**DOCUMENT 00 90 00
ADDENDUM**

ADDENDUM NO. [1] Date: August 14, 2019

**RE: LANESBORO PUBLIC SCHOOLS
 ADDITION AND REMODEL
 100 KIRKWOOD ST EAST
 LANESBORO, MN 55949
 HSR 18063**

**FROM: HSR Associates, Inc
 100 Milwaukee Street
 La Crosse, WI 54603
 (608) 784-1830**

E104P

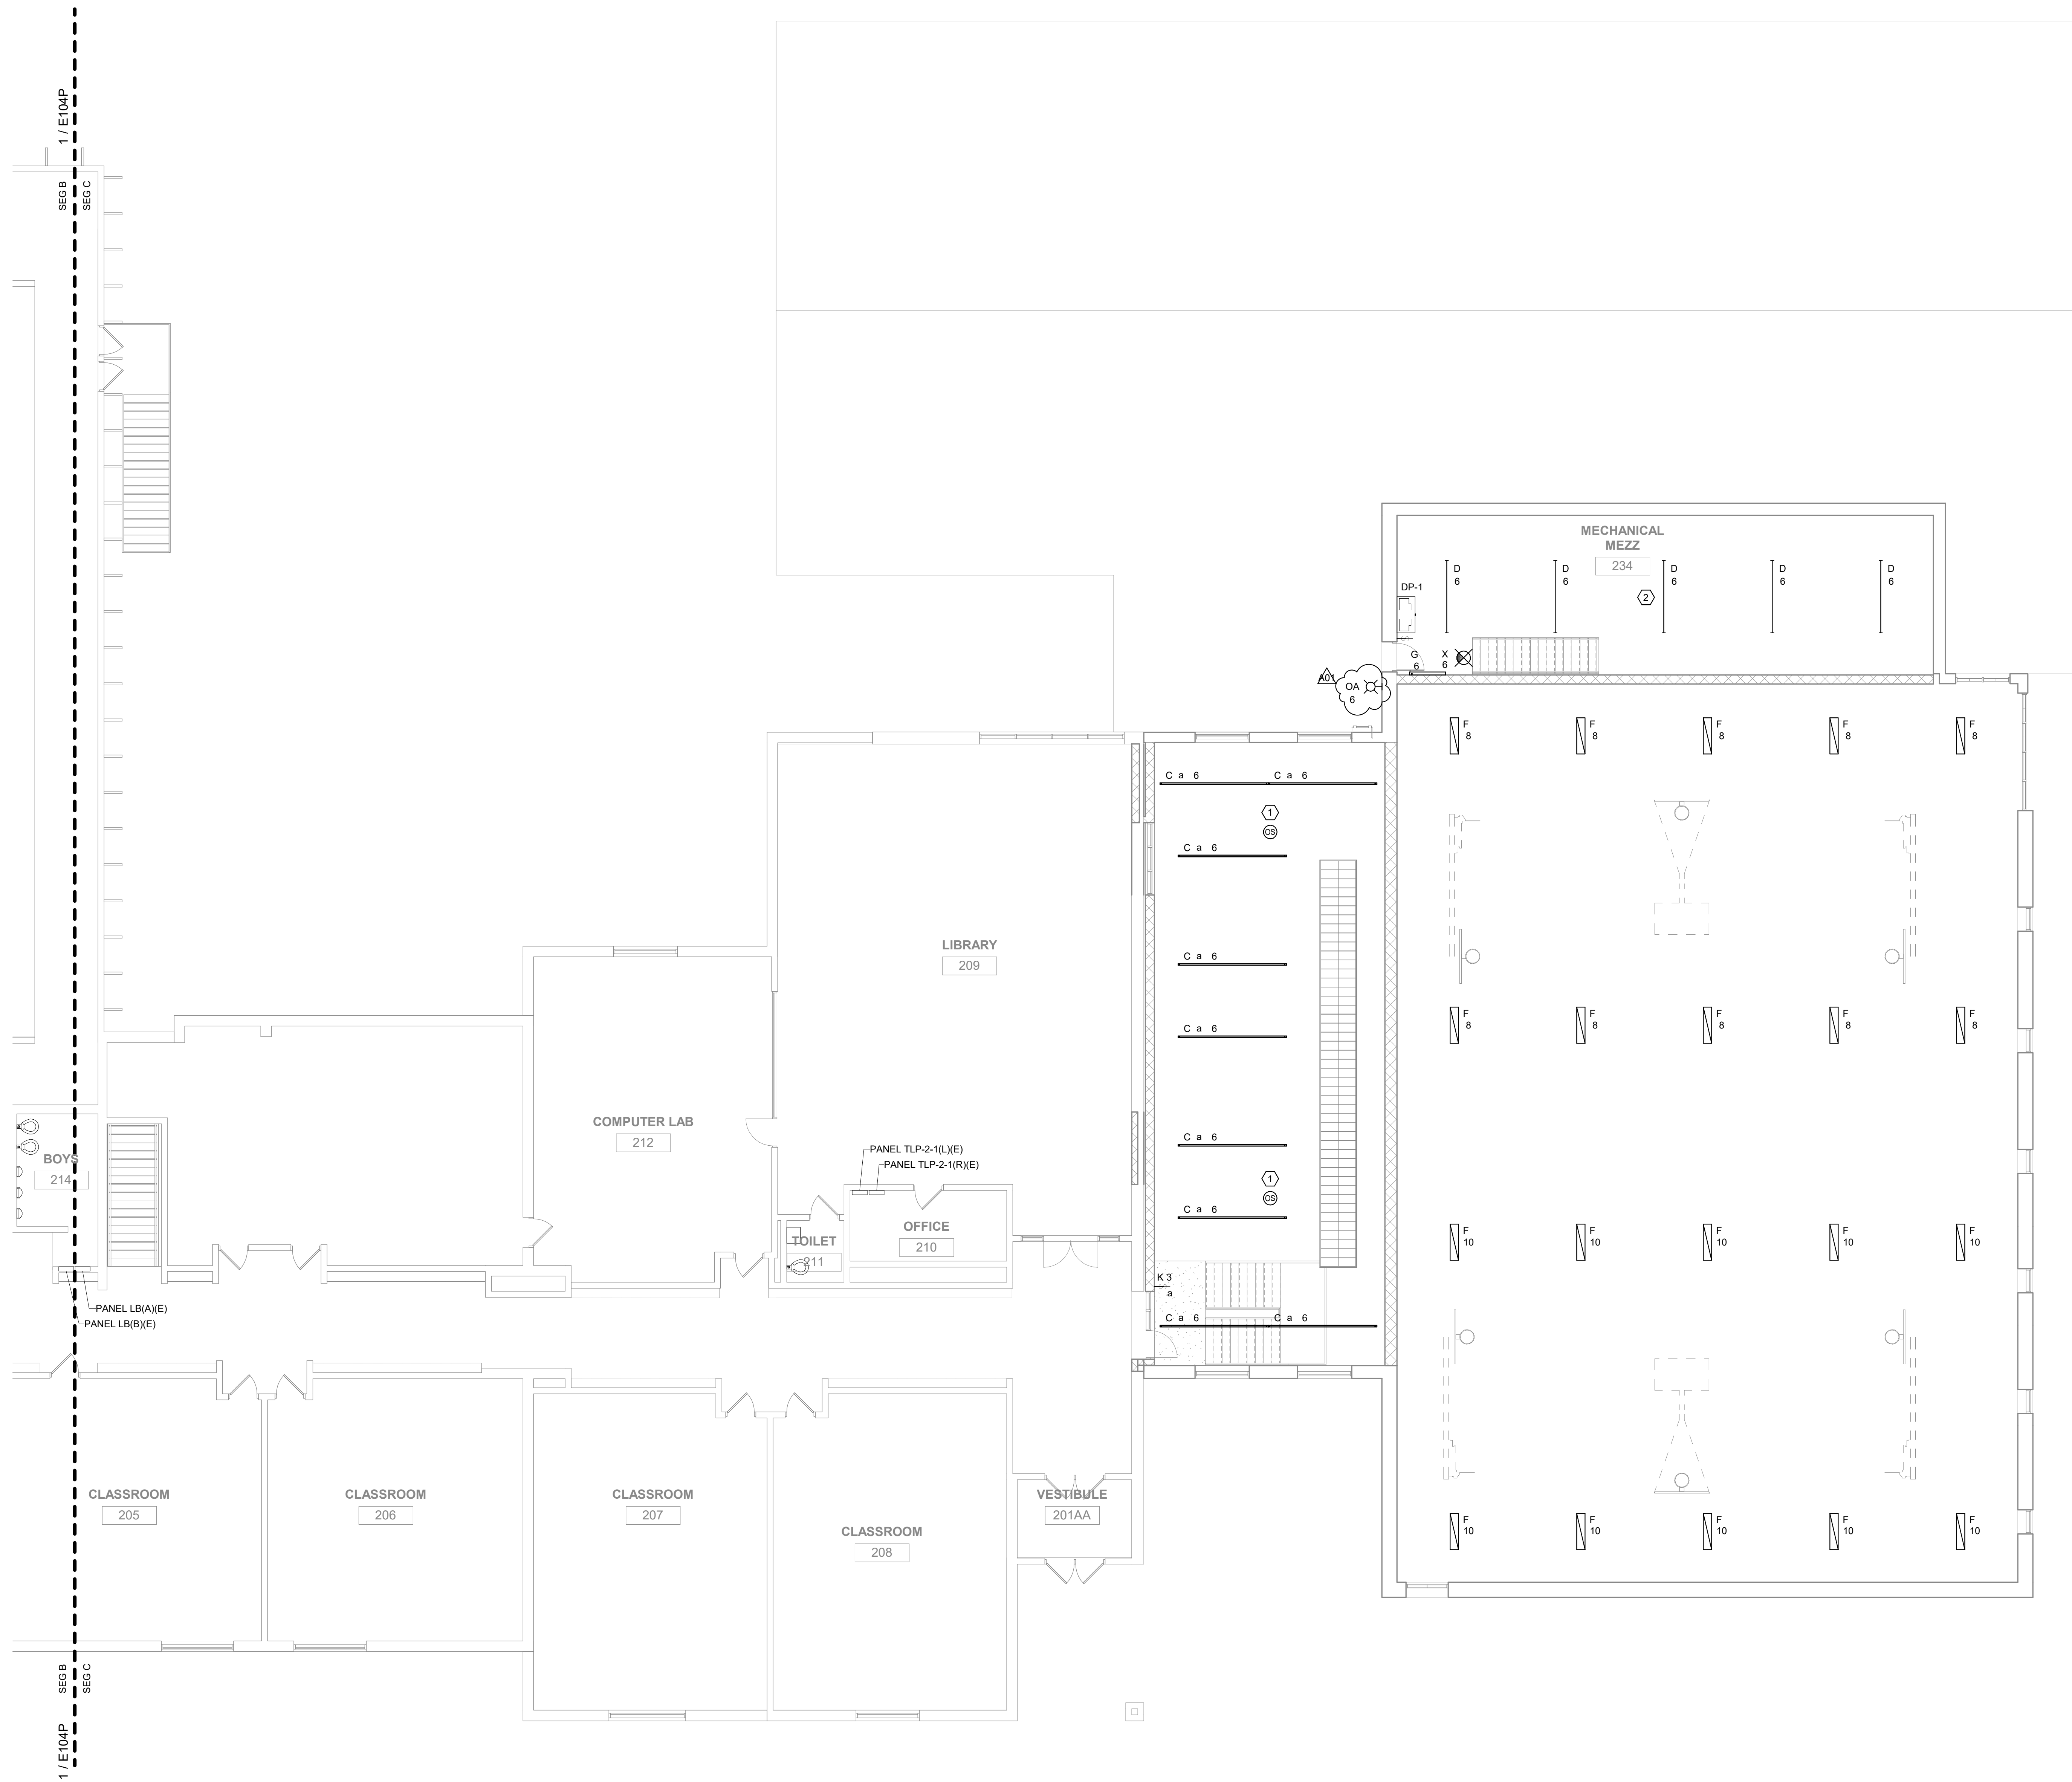
- b. Revise general lighting notes, as shown.
 - c. Revise light switch locations in Upper Commons 152B, as shown.
57. Sheet E104P UPPER LEVEL – SEGMENT B – POWER/SYSTEMS 30 x 42 attached hereto

- a. Revisions clouded on Drawing.
 - b. Add keyed note five to clarify new work for new panel board, as shown.
 - c. Revise door access control device location in Vestibule 200, as shown.

E105L

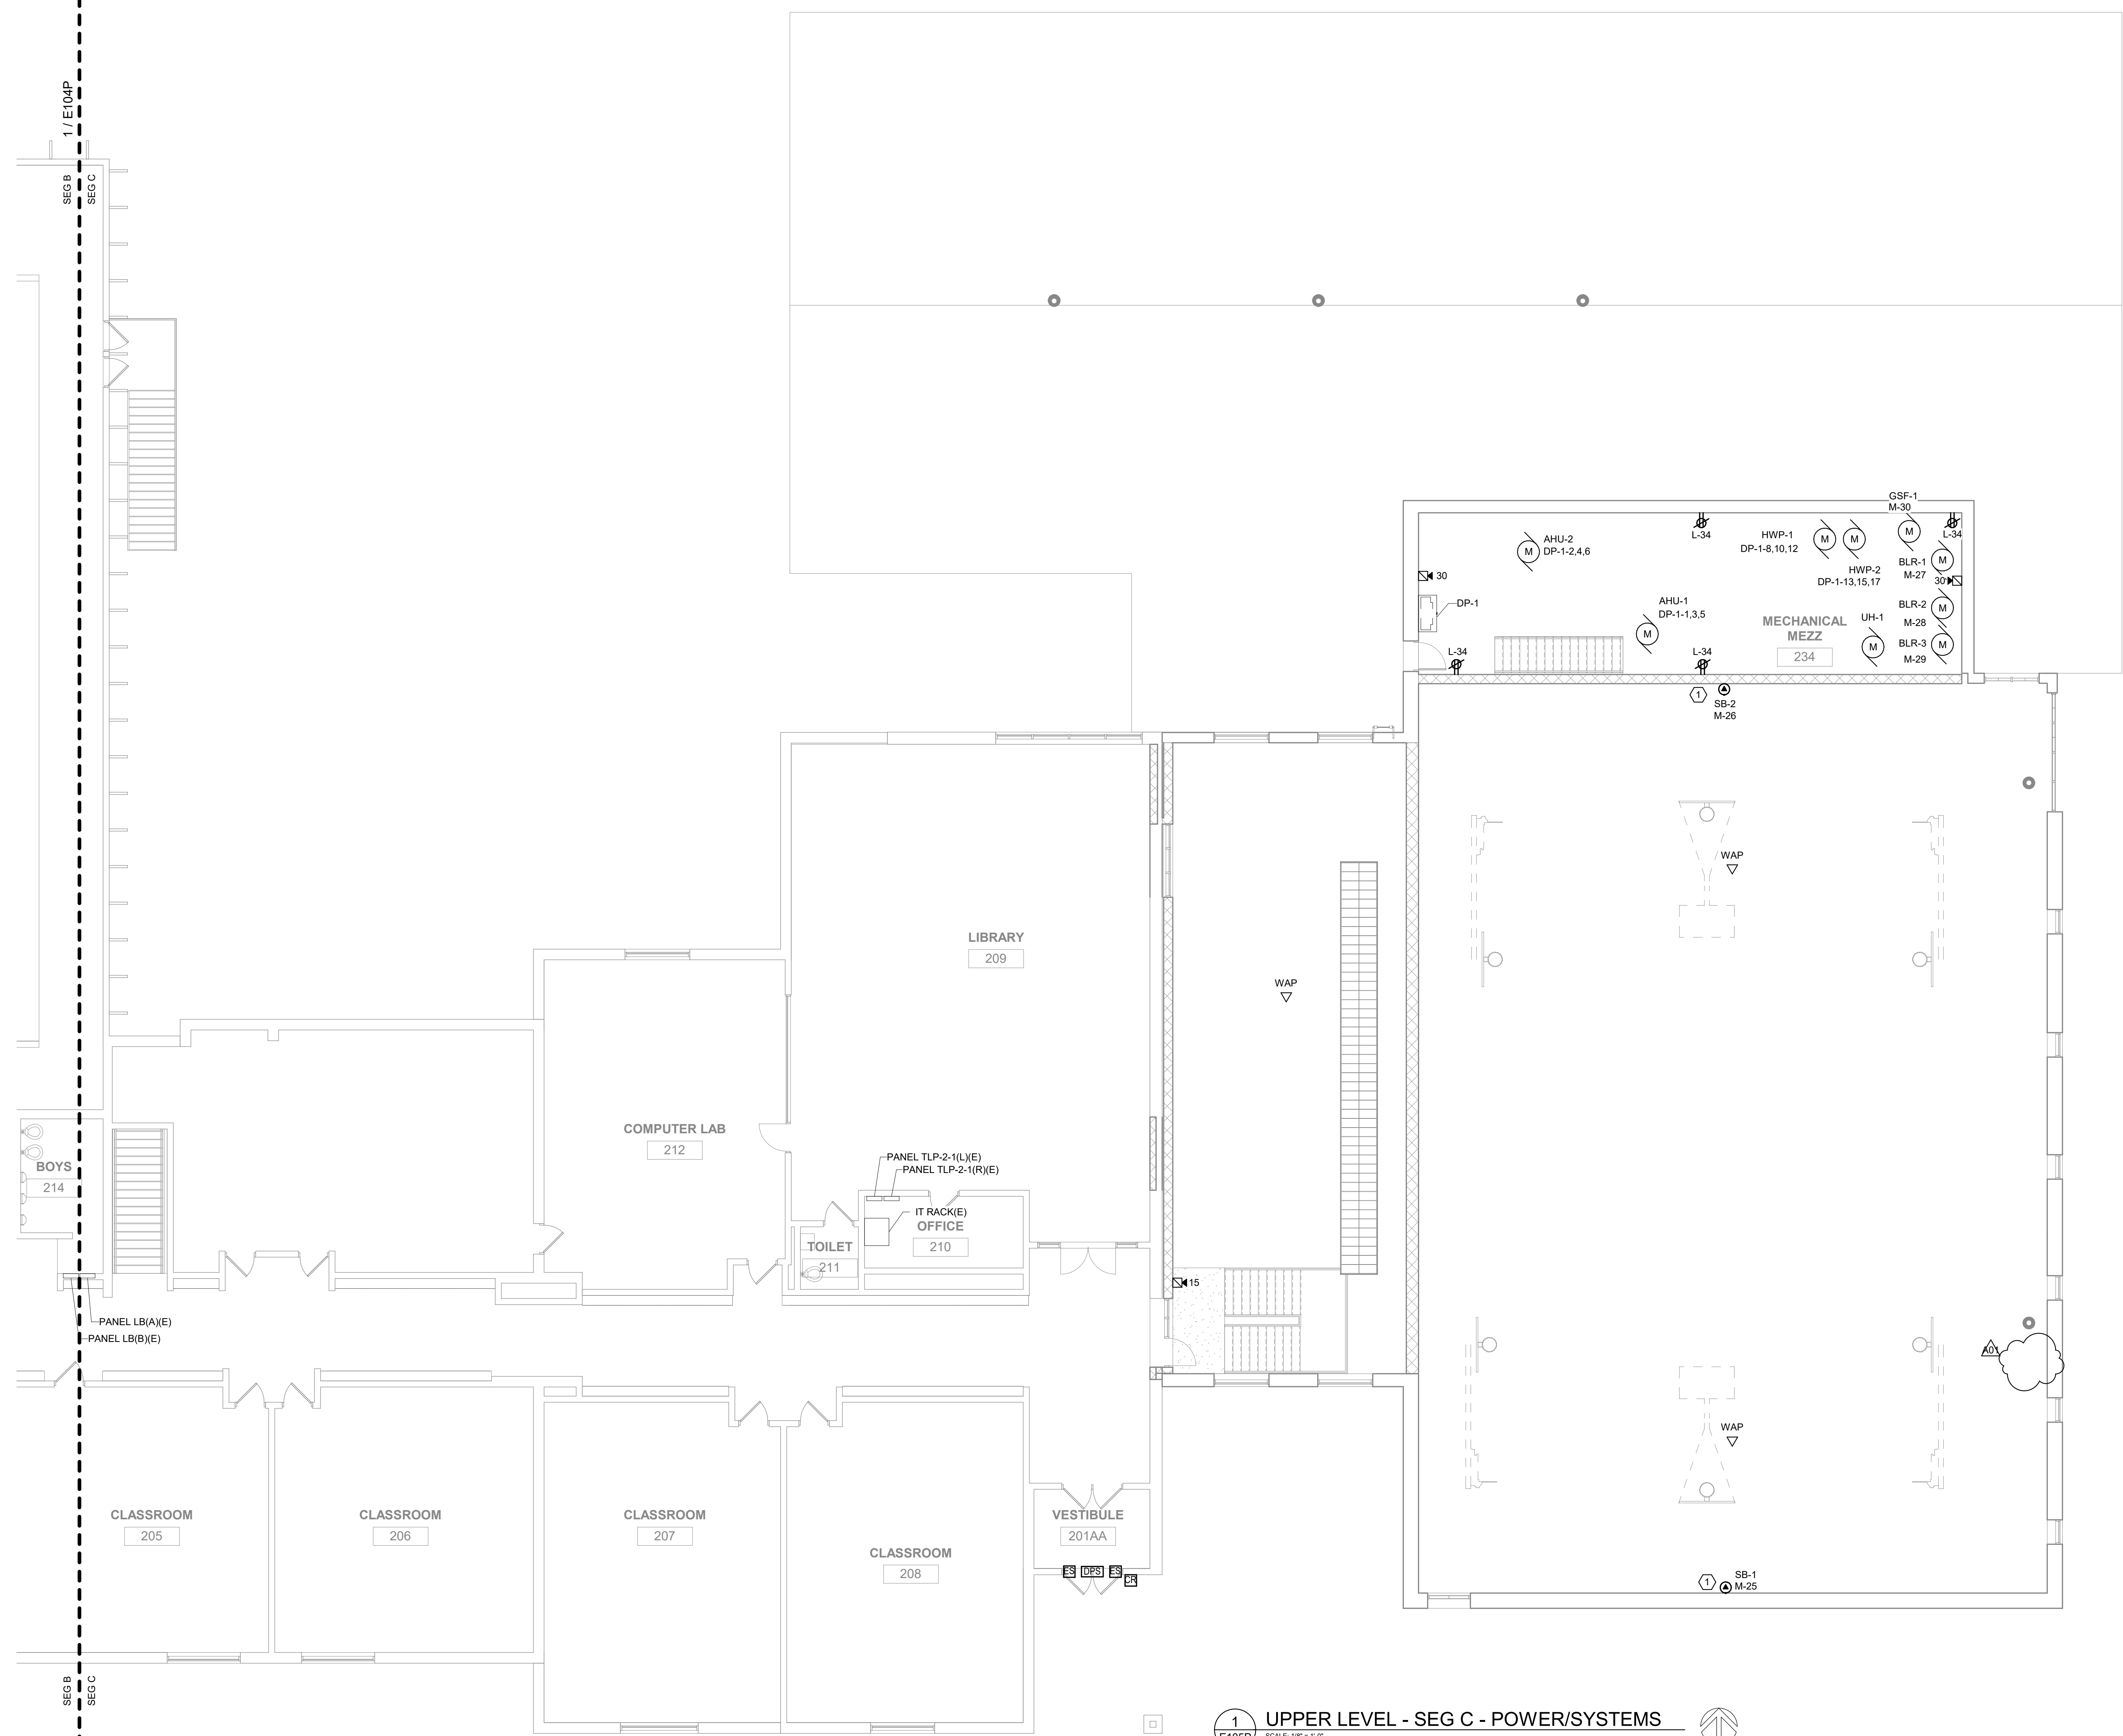
58. Sheet E105L UPPER LEVEL – SEGMENT C – LIGHTING 30 x 42 attached hereto
 - a. Revisions clouded on Drawing.
 - b. Revise general lighting notes, as shown.

- c. Revise exterior type OA fixture location, as shown.
59. Sheet E105P UPPER LEVEL – SEGMENT C – POWER/SYSTEMS 30 x 42 attached hereto
 - a. Revisions clouded on Drawing.

E105P

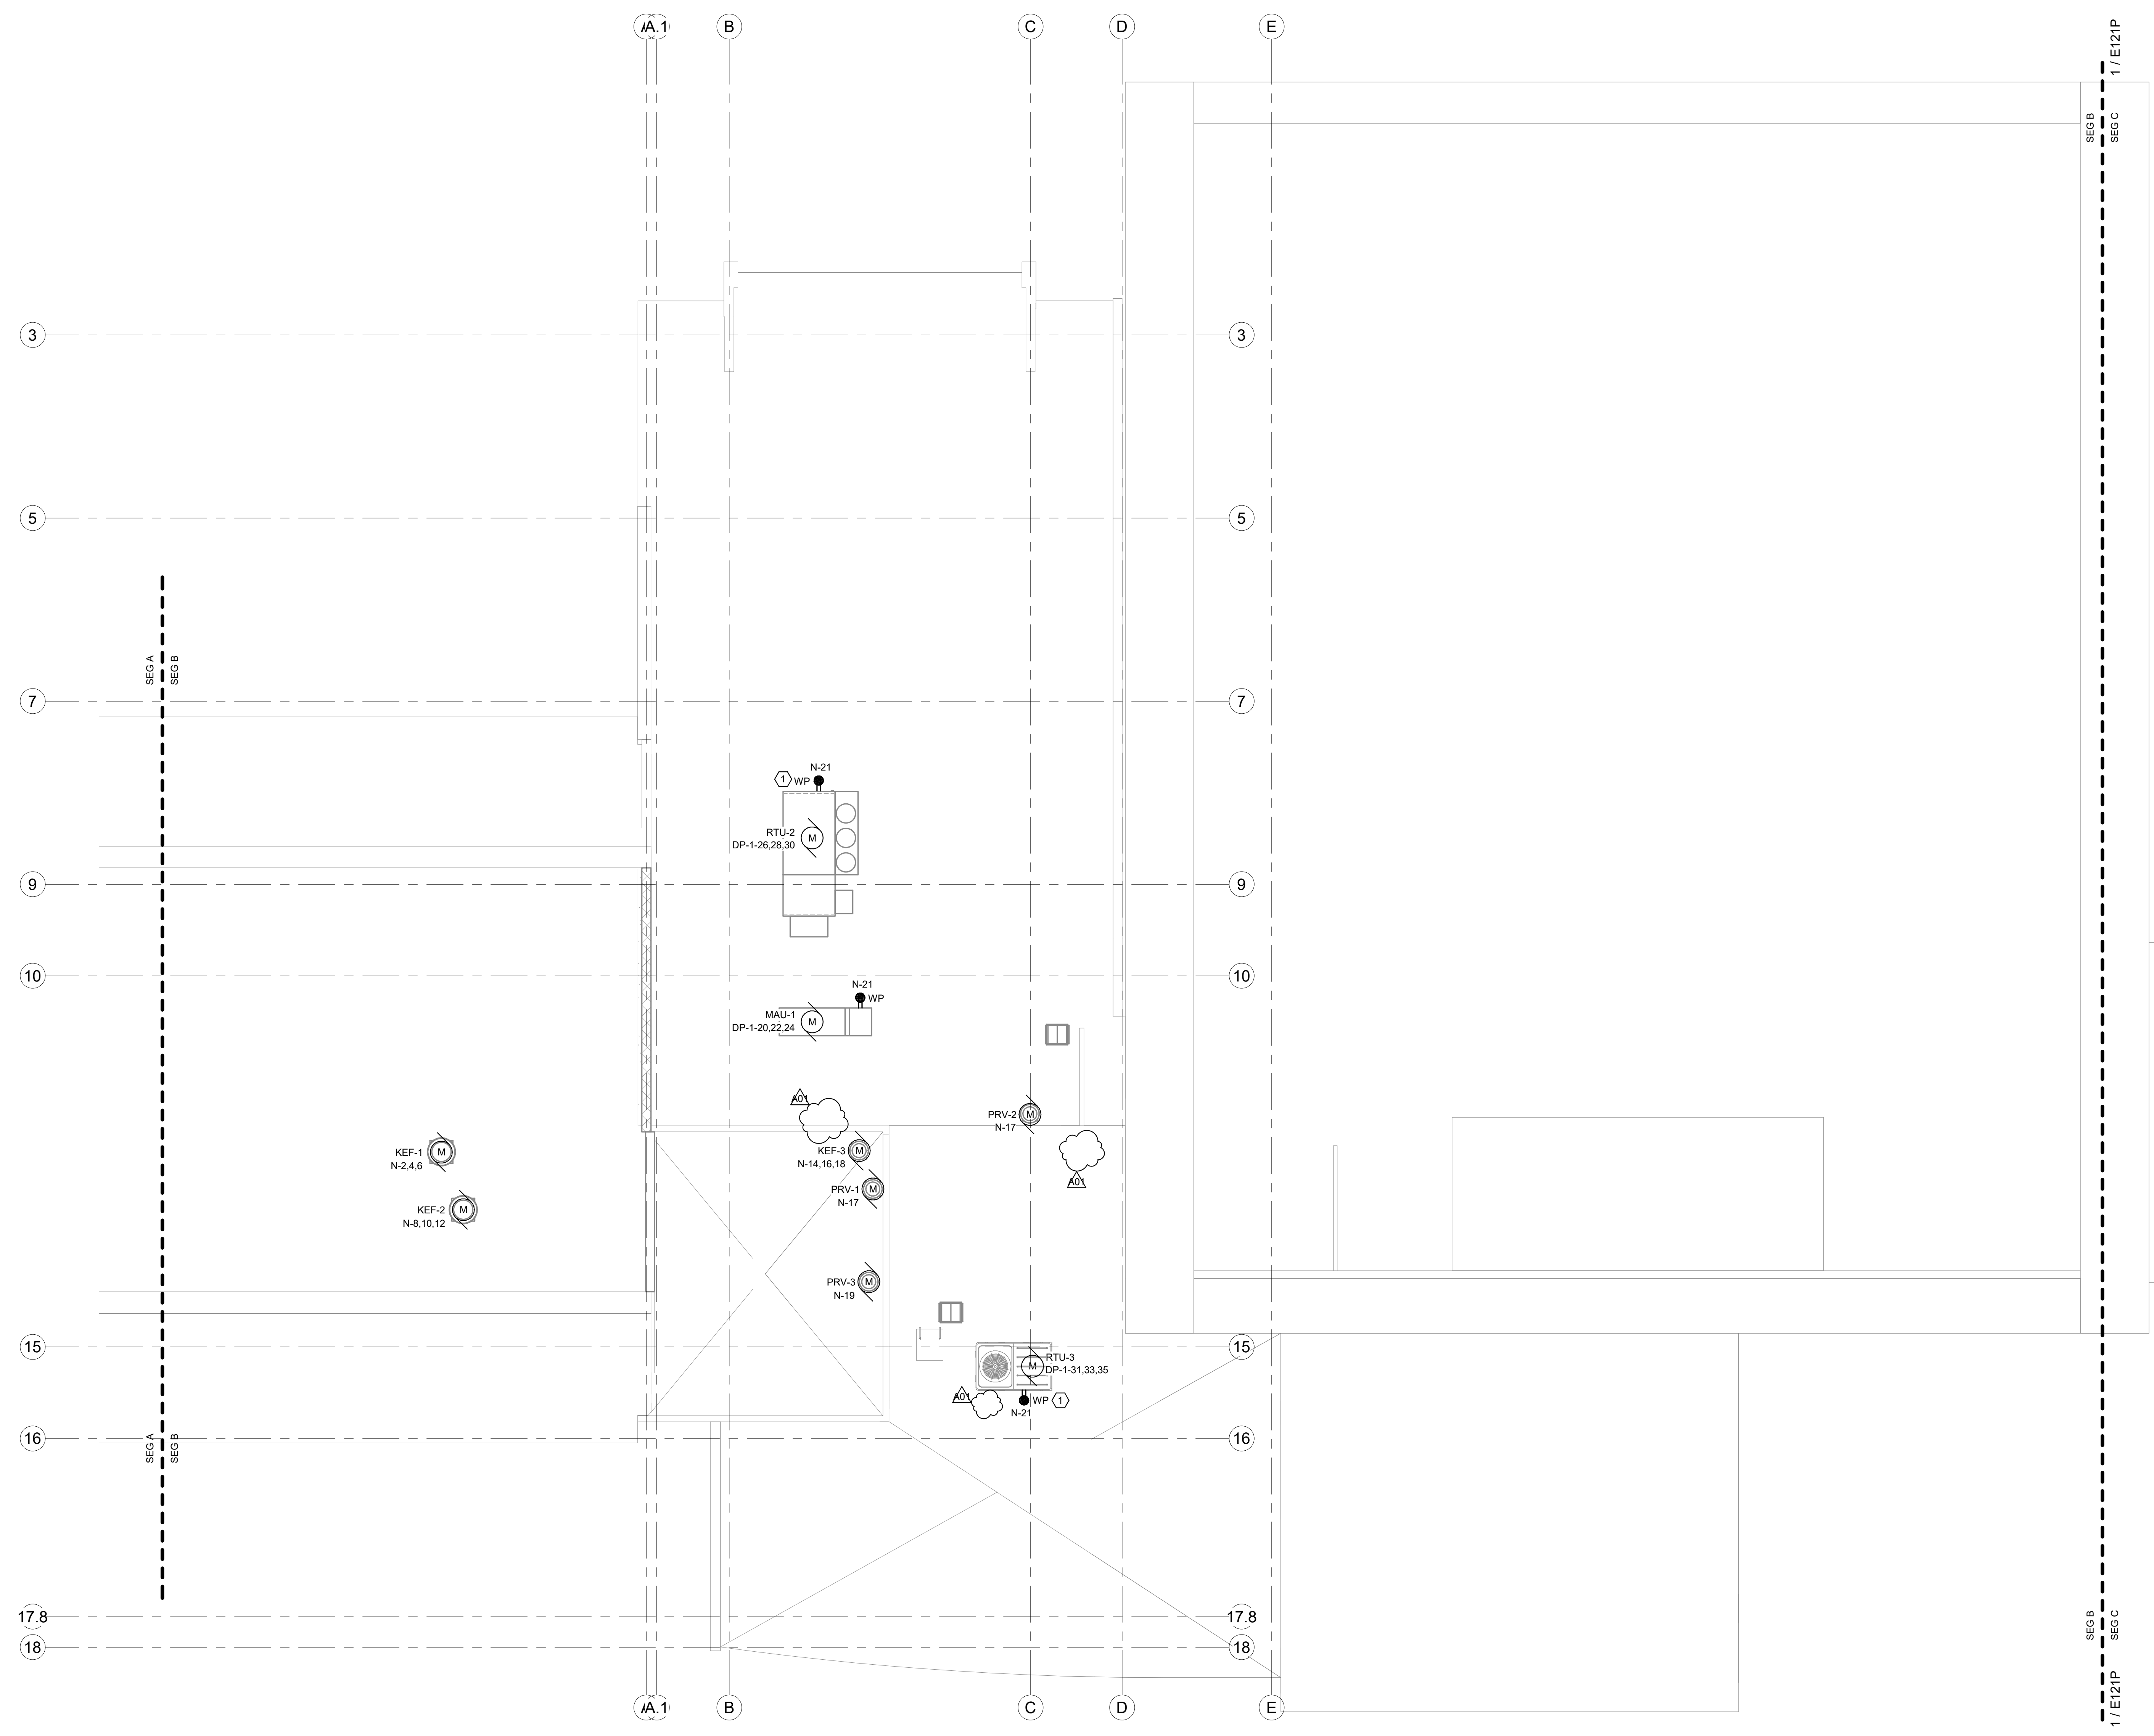
- b. Remove Gymnasium fire alarm notification device, as shown.
60. Sheet E120P ROOF PLAN – SEGMENT B – POWER/SYSTEMS 30 x 42 attached hereto
 - a. Revisions clouded on Drawing.
